# Memo

**To:** Members of Dublin City Council  
**From:** Dana L. McDaniel, City Manager   
**Date:** October 20, 2016  
**Initiated By:** Jennifer D. Readler, Law Director  
Vincent A. Papsidero, FAICP, Planning Director  
Claudia D. Husak, AICP, Senior Planner  
Terry D. Foegler, Strategic Initiatives Director  
**Re:** Request for Appeal – Bridge Park Building B5 (Parking Garage)  
(16-052FDP/FP)

16-060MPR  
 Minor Project Review  
 Building B5 Exterior Modifications  
 6561 Mooney Street

# Proposed Garage Material Changes

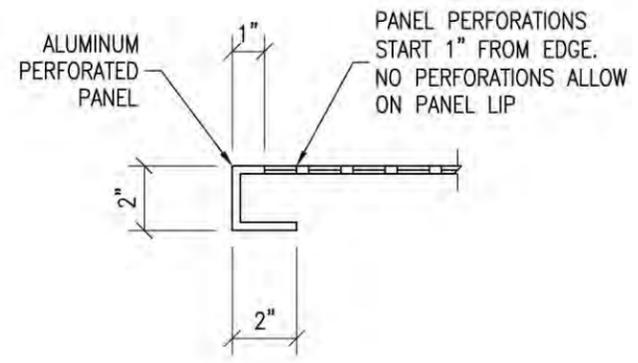
This project proposes changes to the basic design of the exposed portions of the garage facades. The south and east facades remain clad in brick, but additional masonry detail has been added to the brick façades.

Aluminum panels in a staggered vertical pattern cover the majority of the spandrel. The southeast corner has a one story vegetated screen wall rather than the multi-story vegetated screen that had been previously approved.

Ms. Burchett outlined the changes requested by the applicant that included changes to: the brick; the screen style and materials; and the living green façade. She explained the proposed changes are for the eastern and southern elevations only. She said the east elevation faces Mooney Street and the south elevation faces Banker Drive. She affirmed there are no changes proposed for the northern or western elevations; they contain the residential liners. She presented a graphic for context - the previously approved plan that showed the east elevation of the building clad in brick with an overlay of stainless steel mesh screens and the southeast corner that included a full height vegetative screen wall. She explained the spandrel panels were covered with metal mesh rails at the entry points. She explained the south and east facades remain clad in brick, but additional masonry detail has been added; the screen panels have been changed; and the vegetated wall has been decreased in size. She presented a split screen showing the previously approved and proposed east elevations for comparison. She presented additional detail on the modular façade trellis system.

SECTION 2  
3" = 1'-0" SD9

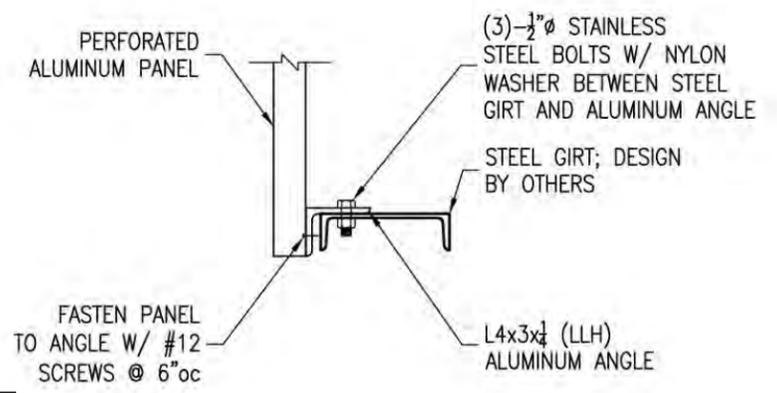
Panels will be a Gray tone not Brown

Previously Approved Elevation

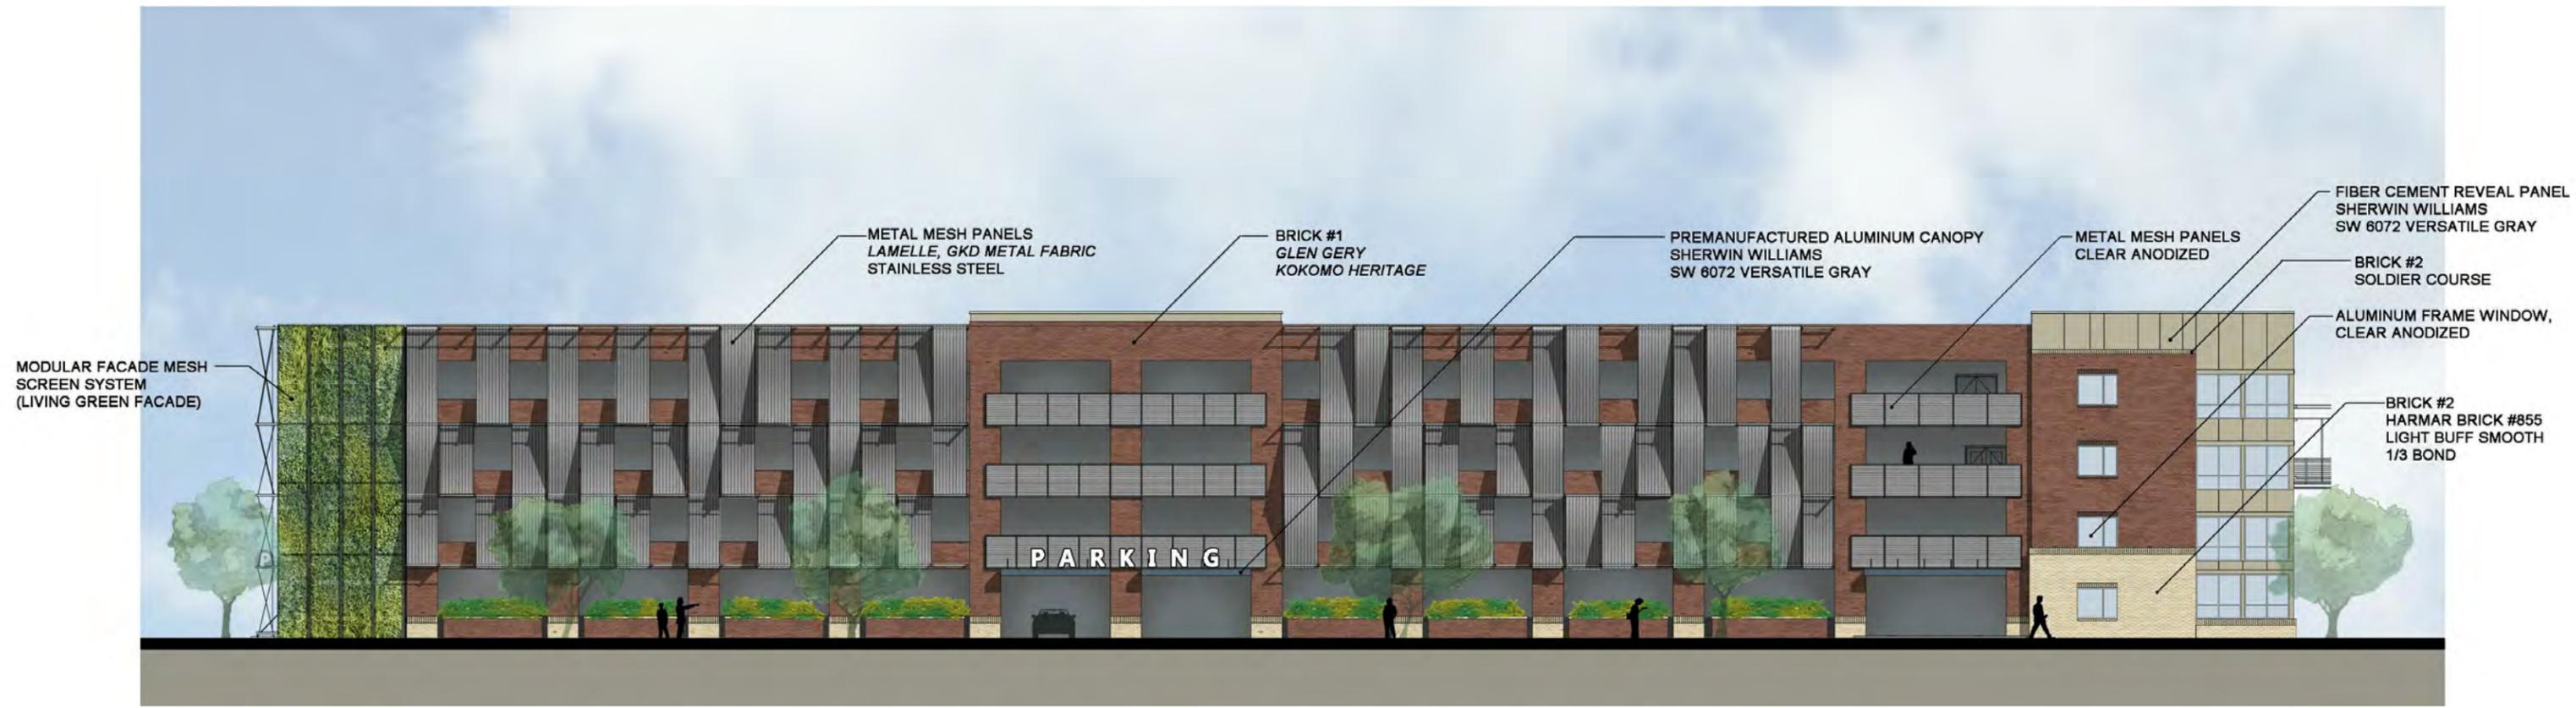
Mr. Brown said the decreased green screen does not make as much of a statement and all of the facades appear to be two-dimensional. He indicated this was the one structure that had a dynamic façade. He said he has worked with perforated panels and mesh screens and asked why the panels are not being angled in and out for variety. He said there are other ways to value engineer and this proposed revised plan is a big disappointment. He said he understands it is a parking garage but it is in close proximity of the hotel, etc. and does not provide for a very dynamic streetscape. He disagreed the brick was highly detailed and instead was very flat and everything in Bridge Park so far is very flat. He indicated he misses articulation and character. He referred to the Arena District that is a higher dollar per square foot but every one of the buildings has some detail, variety, and articulation of their façade.

Ms. Newell said she did not consider this a minor change; this completely changes the rhythm of this building. She recalled when they considered variances, they were looking at the buildings in congruity with each other. She said part of the reason they got to the design they did was to get rid of the vertical emphasis on the buildings. She said the goal in the BSD is to have different buildings without sameness. She said these modifications are repeating a very prominent vertical pattern that goes all the way down the street. She restated this is a huge change to the architecture of the building. She said it had great energy before, there was a playfulness through the shadows on the façade, and they had requested the parking garages not appear as parking garages. She said several designs of this building were discussed during the review process and it was the playfulness of the panels and the green wall that sold the Commission on the final design. **She indicated this seems like a 'bait and switch' tactic.**
